Table 2.1 D.C. Cook Unit 2 LOCA/ECCS Analysis Summary

Results for the Cycle 5 Core Configuration (85% ENC Fuel)

ATTACHMENT 2  
PROPOSED REVISION TO TECHNICAL  
SPECIFICATION PAGES

FIGURE 3.2-4 RCS TOTAL FLOWRATE VERSUS R - FOUR LOOPS IN OPERATION

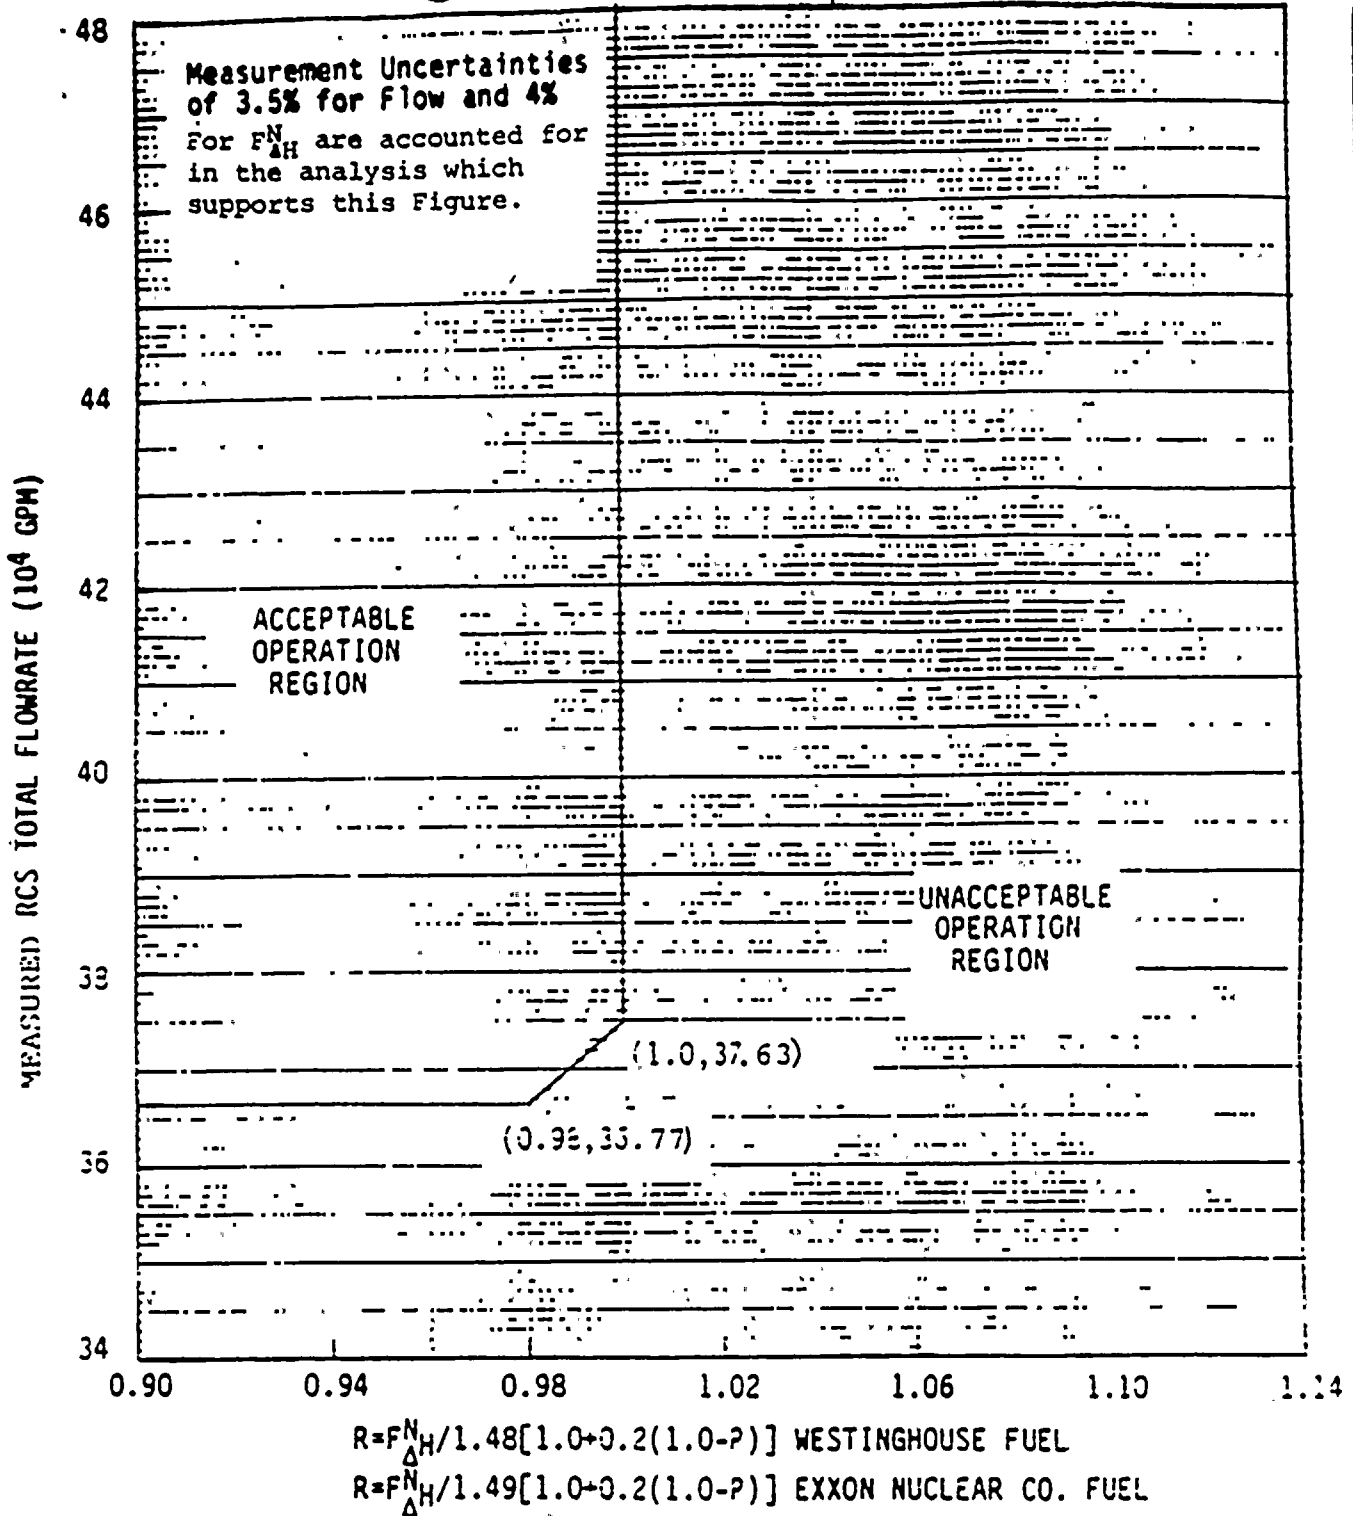
3.2.3 The combination of indicated Reactor Coolant System (RCS) total flow rate and R shall be maintained within the region of allowable operation shown on Figures 3.2-4 and 3.2-5 for 4 and 3 loop operation, respectively.

$$R = \frac{F_{\Delta H}^N}{1.48 [1.0 + 0.2 (1.0 - P)]} , \quad R = \frac{F_{\Delta H}^N}{1.49 [1.0 + 0.2 (1.0 - P)]}$$

And,  $F_{\Delta H}^N \leq 1.36/P$  for Exxon Nuclear Company Fuel

With  $F_{\Delta H}^N$  above the allowable limit or with the combination of RCS total flow rate and R outside the region of acceptable operation shown on Figure 3.2-4 or 3.2-5 (as applicable):

$$R = F_{NH}^N / 1.48 [1.0 + 0.2(1.0 - P)] \text{ WESINGHOUSE FUEL}$$

$$R = F_{NH}^N / 1.49 [1.0 + 0.2(1.0 - P)] \text{ EXXON NUCLEAR CO. FUEL}$$

FIGURE B 3/4 2-2 ILLUSTRATIVE EXAMPLE OF  
 $F_{\Delta H}^N$  LIMIT VERSUS PERCENT THERMAL POWER FOR EXXON FUEL

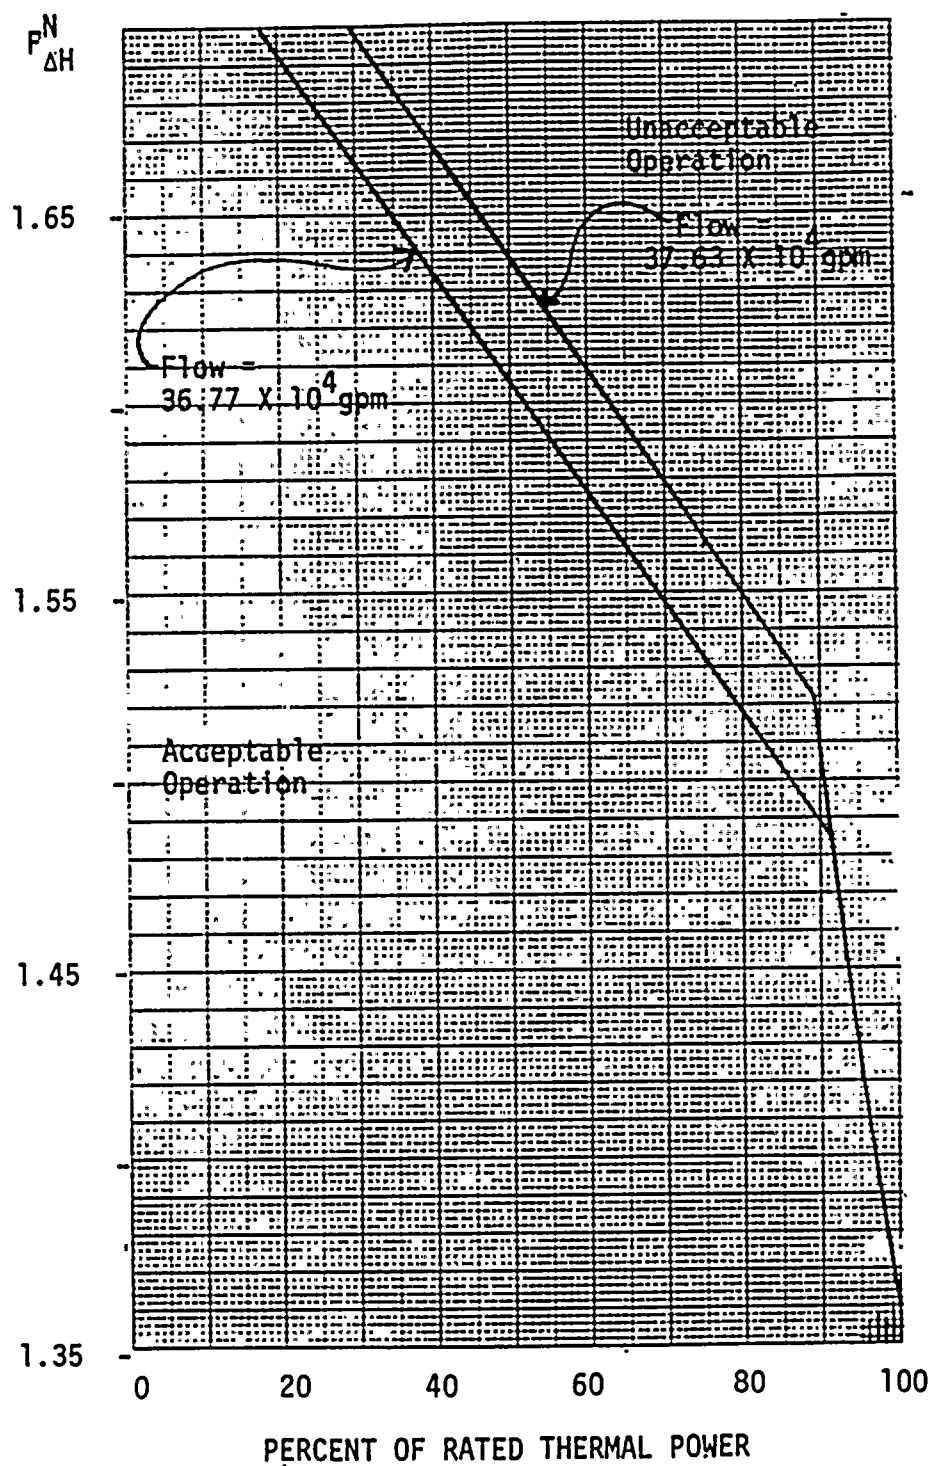
Figure B 3/4 2-2 illustrates the implementation of the limits as a function of power. A measured flow will result in a limiting value for R which must be obtained from Figure 3.2-4 or Figure 3.2-5. From this limiting R, a limiting  $F_{\Delta H}^N$  can be obtained because:

Figure B 3/4 2-2 displays two limiting DNBR  $F_{\Delta H}^N$  curves for Exxon Nuclear Company fuel for flows of  $36.77 \times 10^4$  gpm, and  $37.63 \times 10^4$  gpm. Also displayed on Figure B 3/4 2-2 is the limit on  $F_{\Delta H}^N$  which results from the LOCA analysis for Exxon Nuclear Company fuel.  $F_{\Delta H}^N$  must be maintained below and to the left of both the applicable DNBR  $F_{\Delta H}^N$  limit and the LOCA  $F_{\Delta H}^N$  limit.

For Westinghouse fuel there is only one  $F_{\Delta H}^N$  limit. It must be obtained from the applicable relationships among R,  $F_{\Delta H}^N$ , P, and flow.
